Division of Reclamation,
Mining and Safety

November 09, 2016

**RE: Midwestern Farms, Permit No. M-1993-059, Technical Revision No. 5 (TR-05)
Notice of Receipt, Adequacy Review No. 1**

EXHIBIT E-2

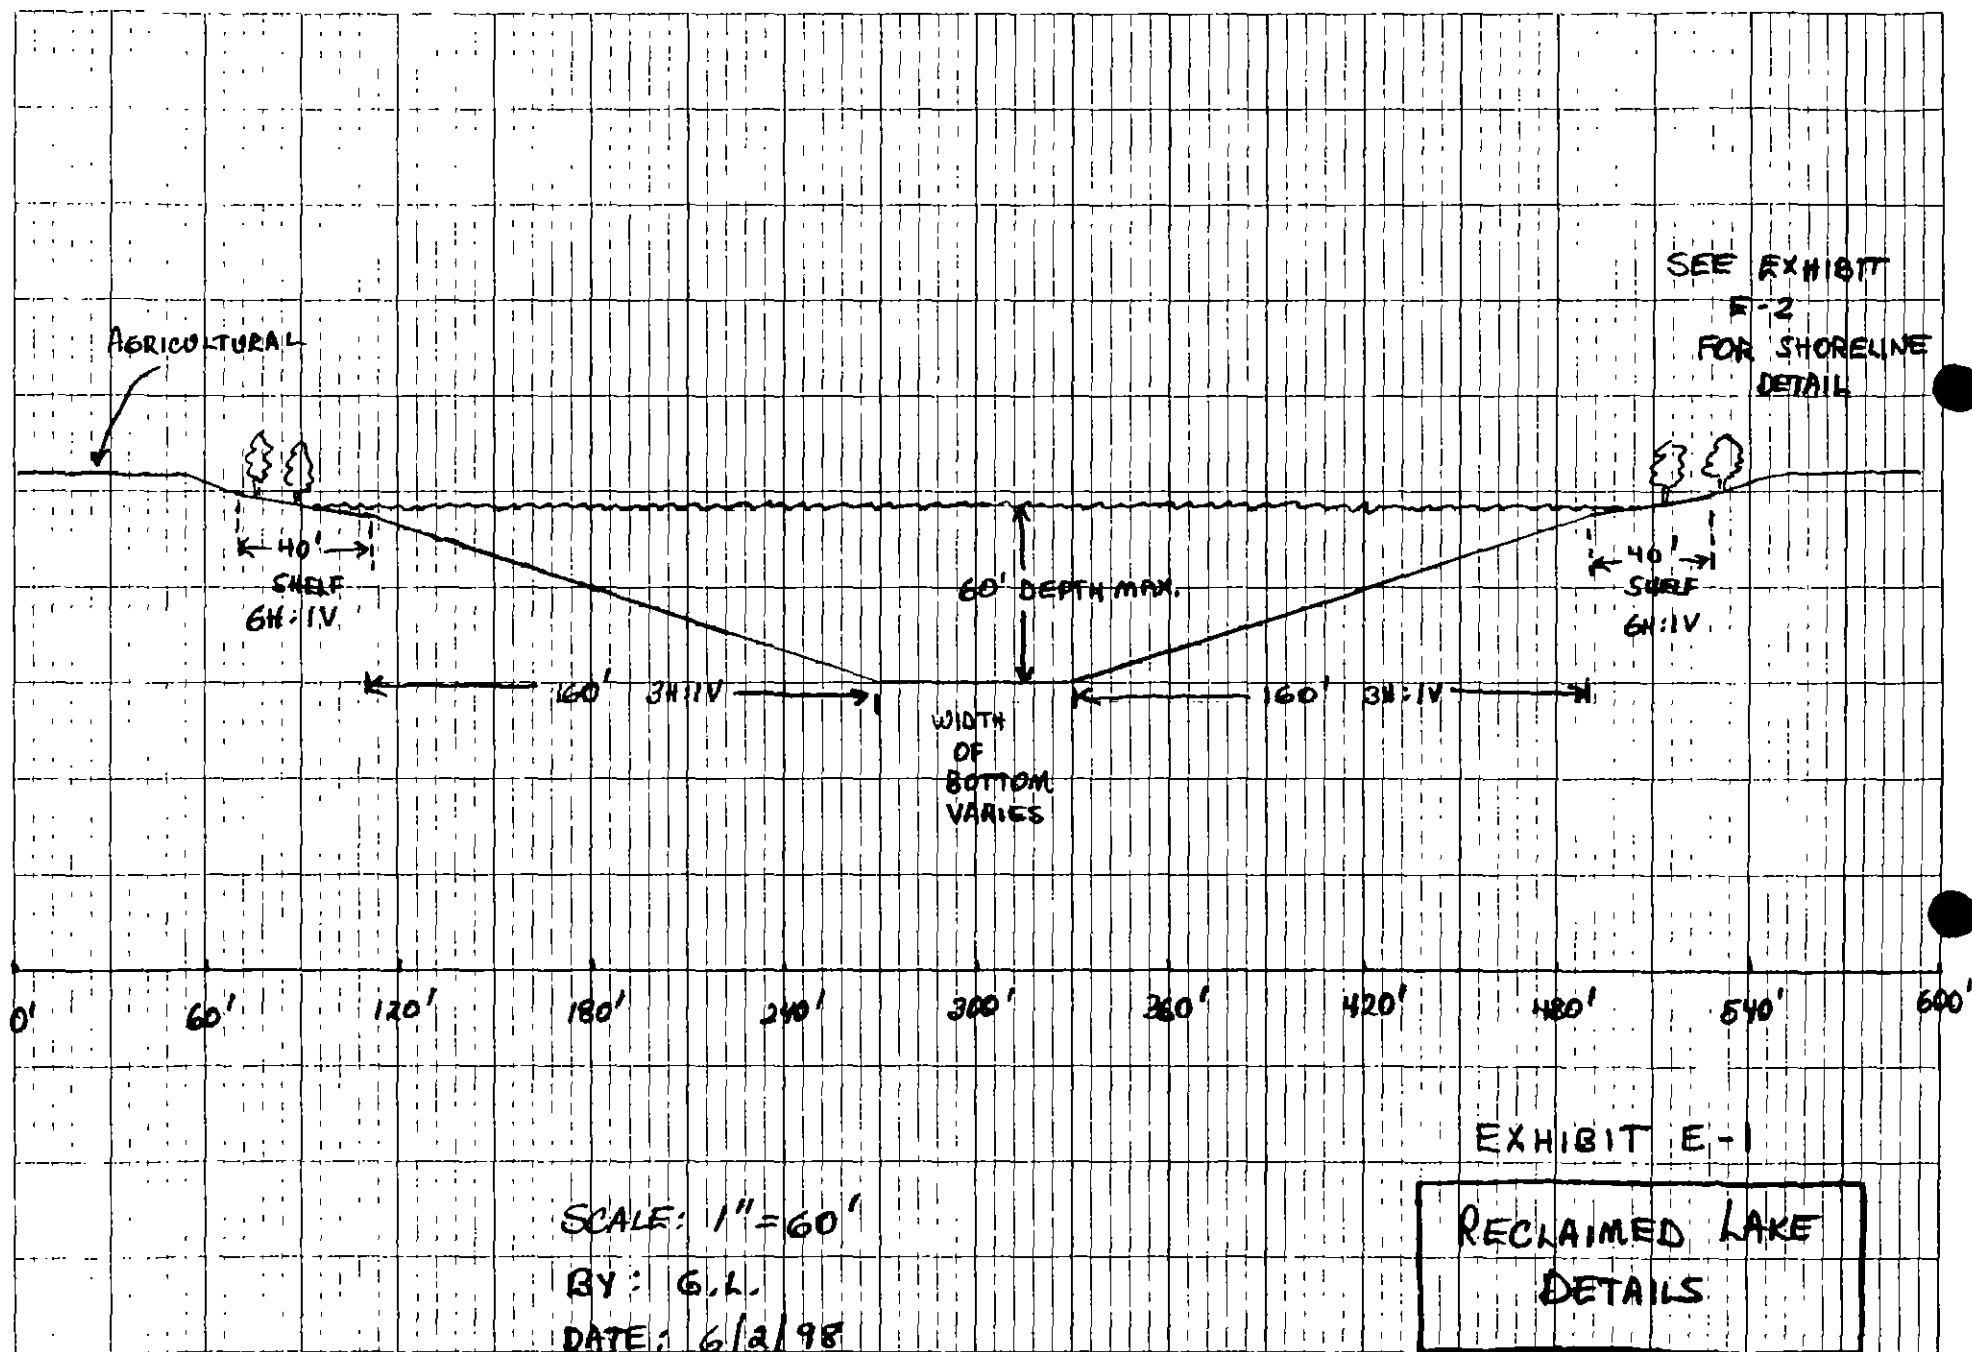
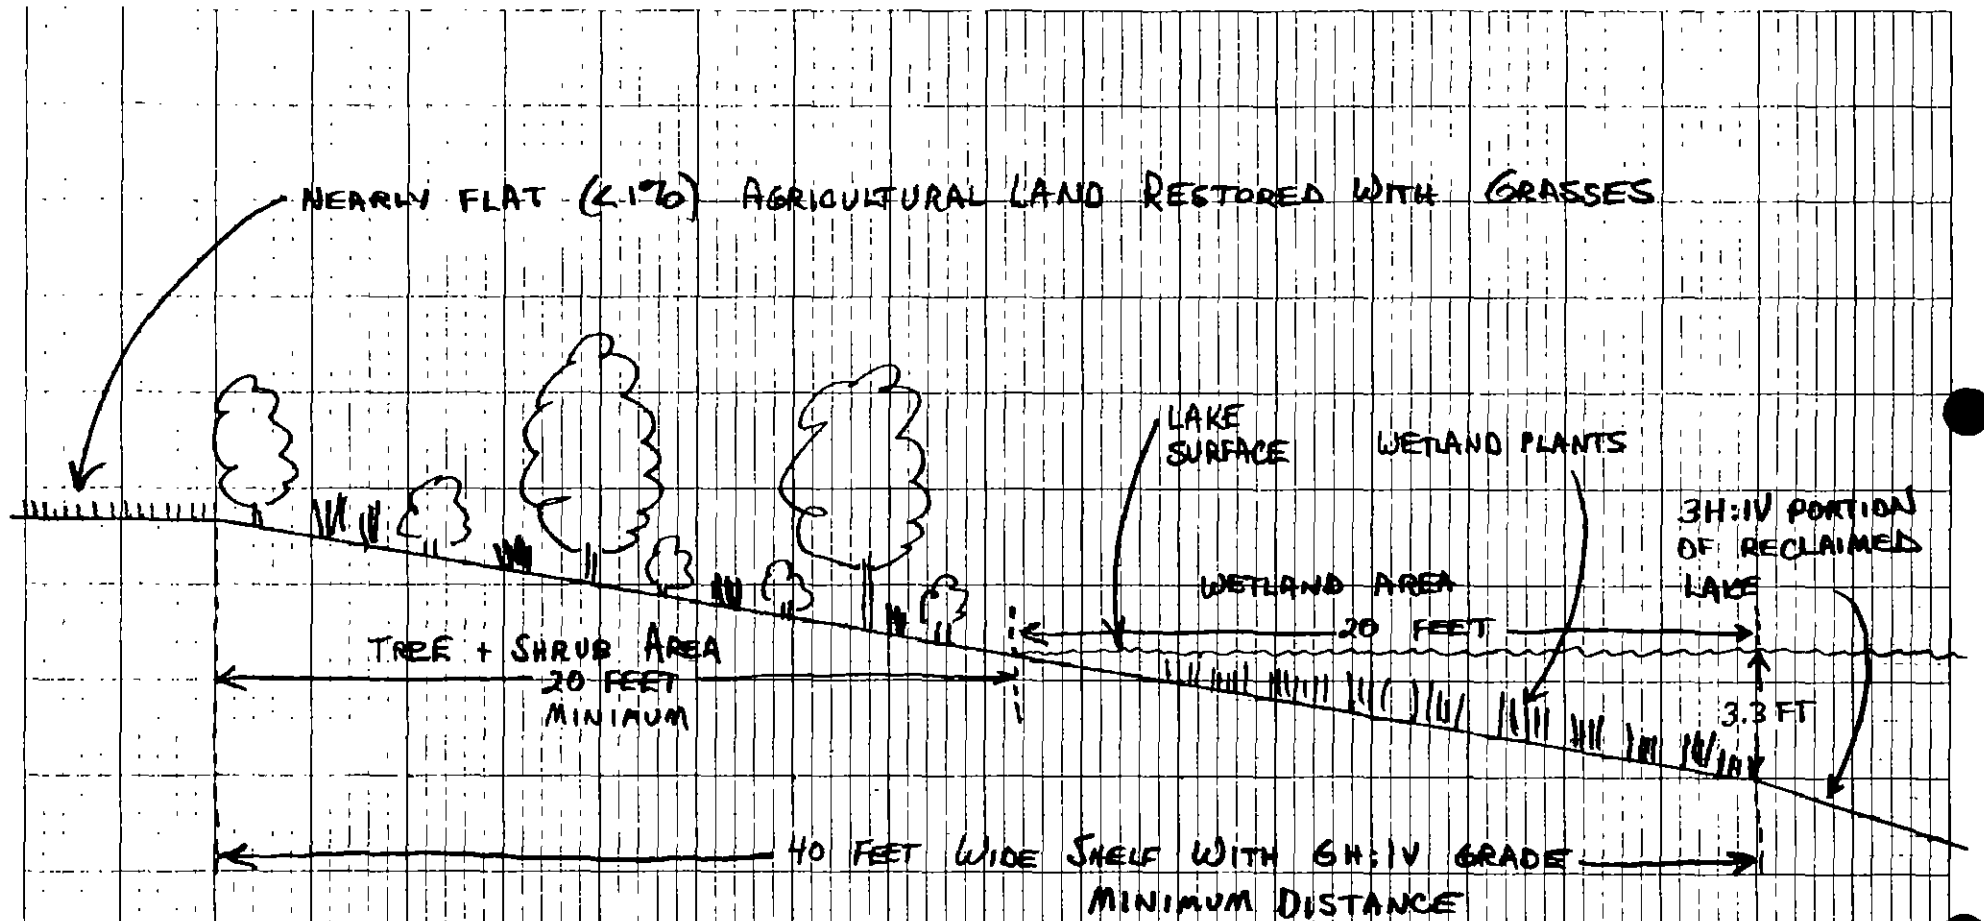
- 2) The revised text states “The sideslopes of the lake will be reclaimed to a final slope ranging from 3H:1V to 6H:1V for a distance of 30 feet into the lake”. How does the operator intend to achieve these slope gradients below water line? Will the lakes be dewatered? What equipment will be used to complete final grading of the lake shorelines? Please provide revised E-1 and E-2 cross-sections showing proposed reclaimed shoreline details (original E-1 and E-2 enclosed).

M1993-059 / Midwestern Farms / Midwestern Farms

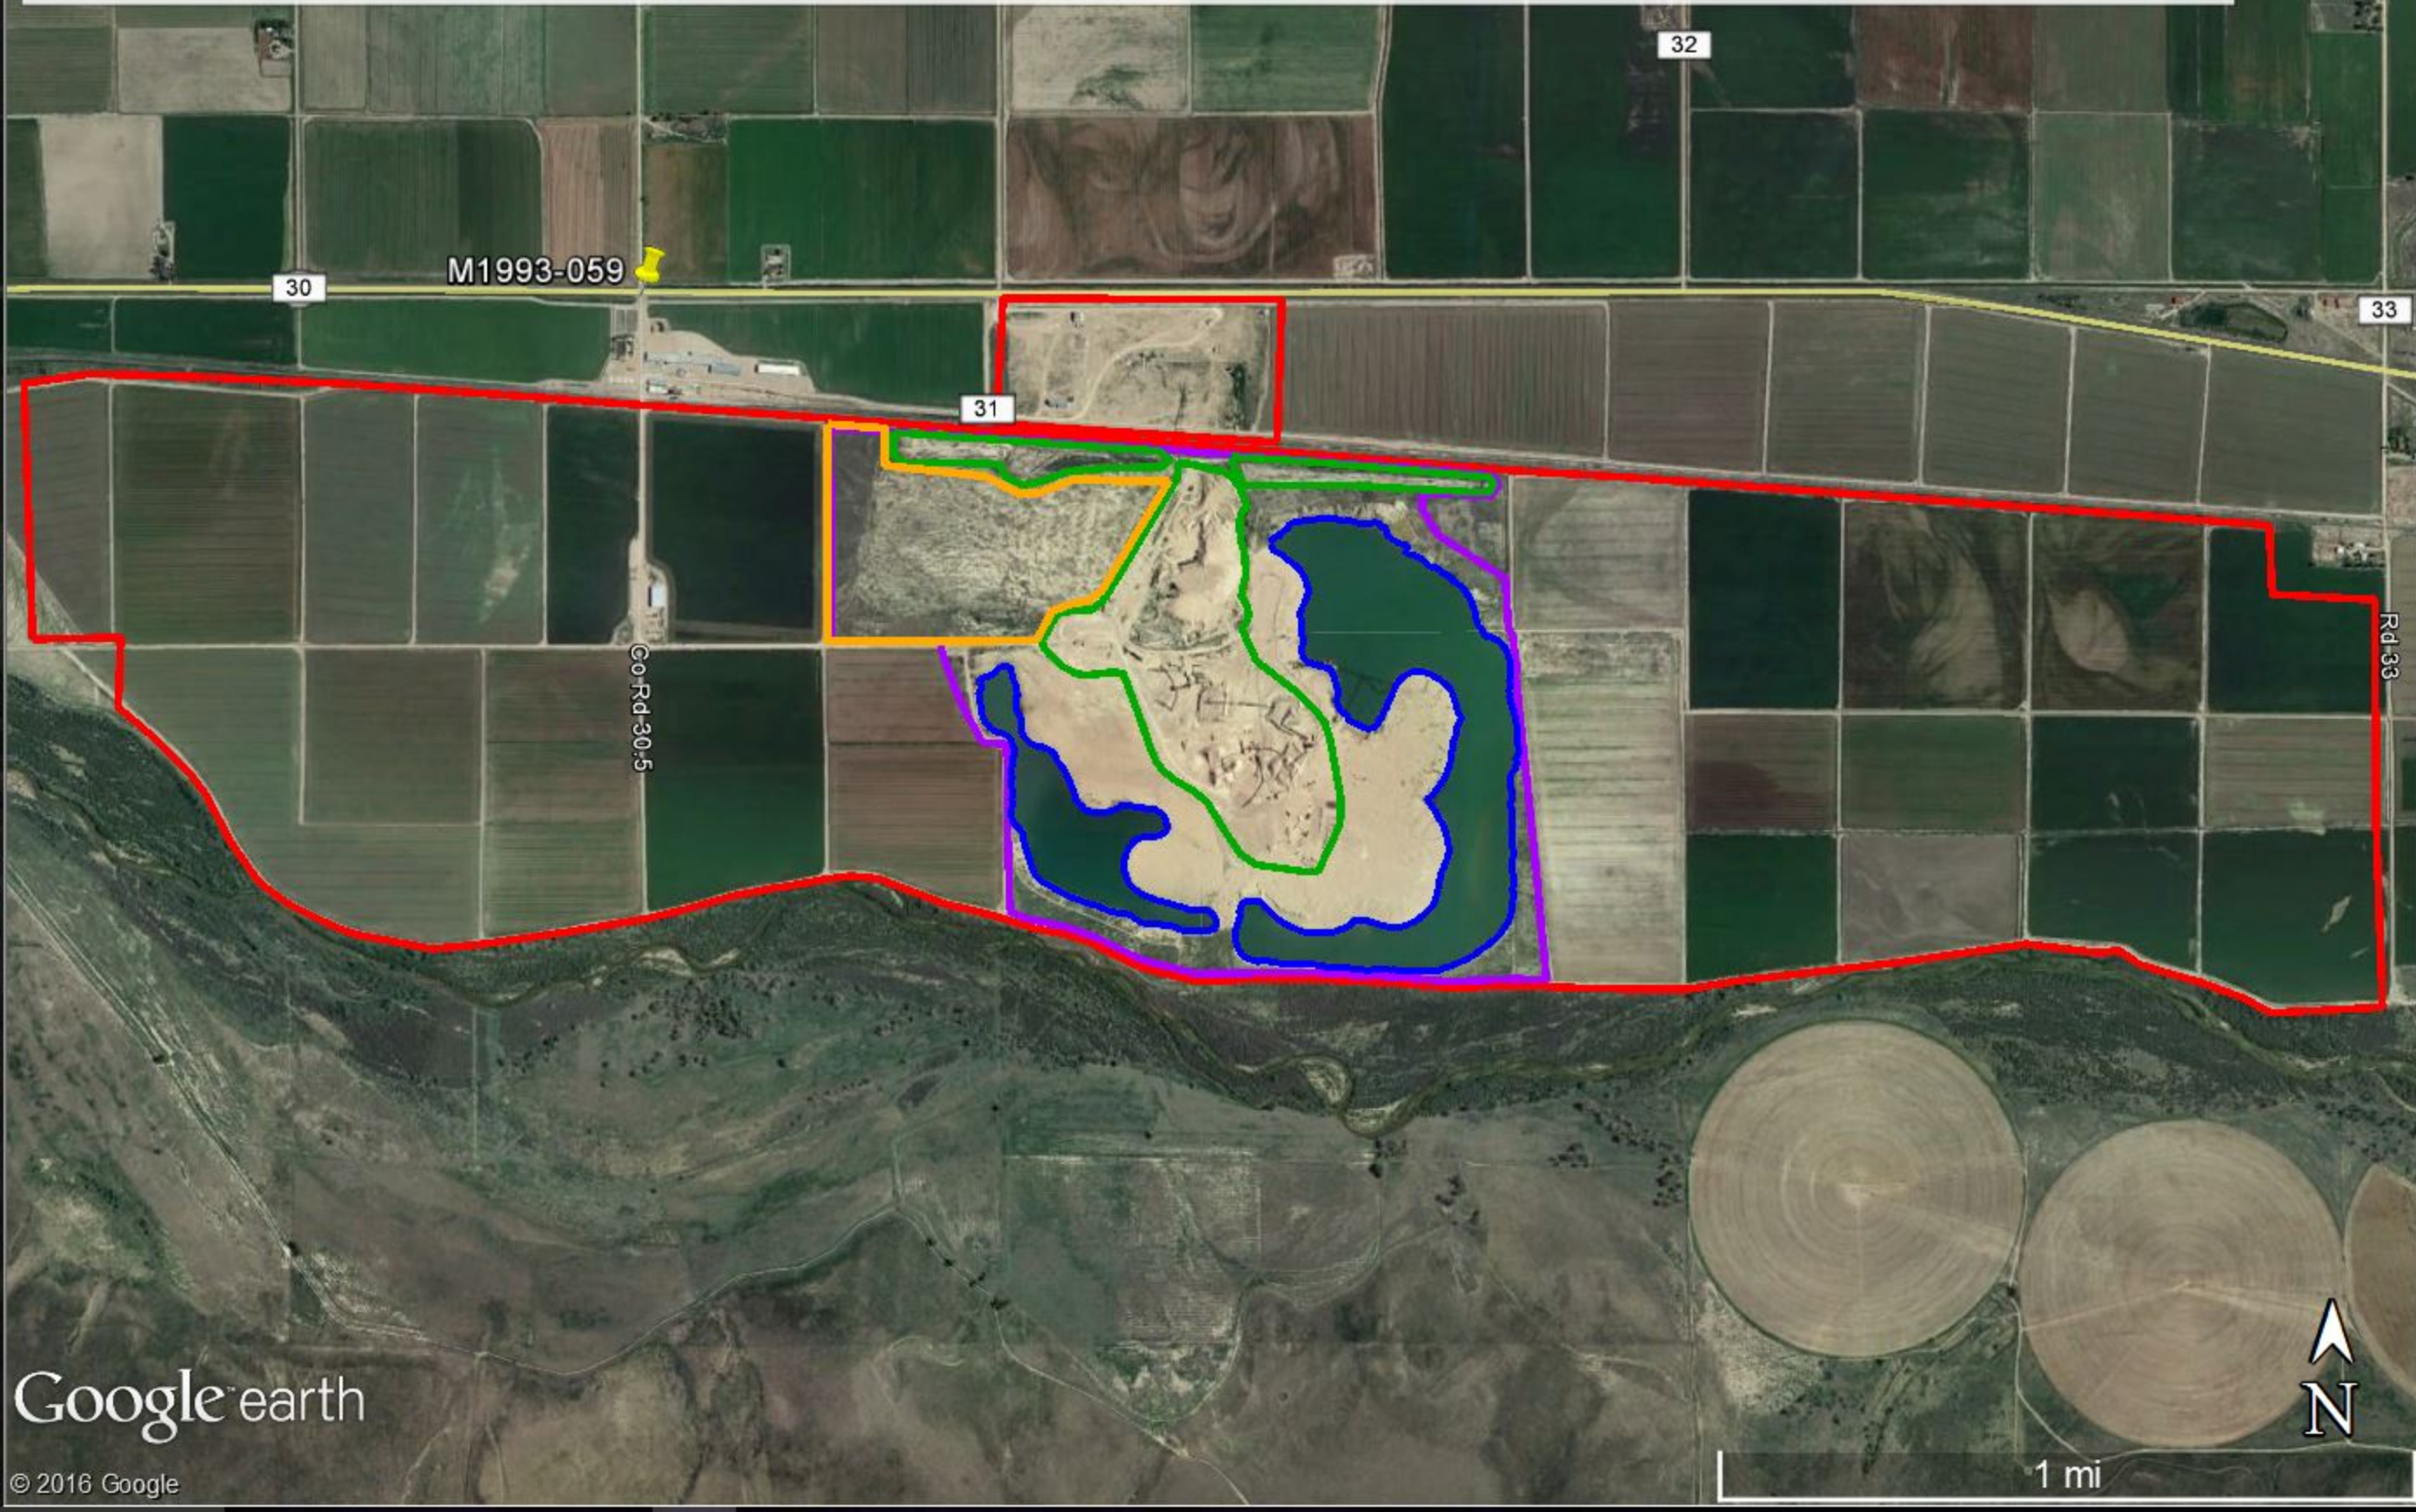
- 19) The revised Exhibit L should include costs for ripping the sand stockpile area and topsoil stockpile areas. The Division estimates a total of 73 acres for the entire processing and sand stockpiling area, and a total of 16.6 acres for the topsoil stockpile areas (see enclosed Google Earth images of site with Division markings).
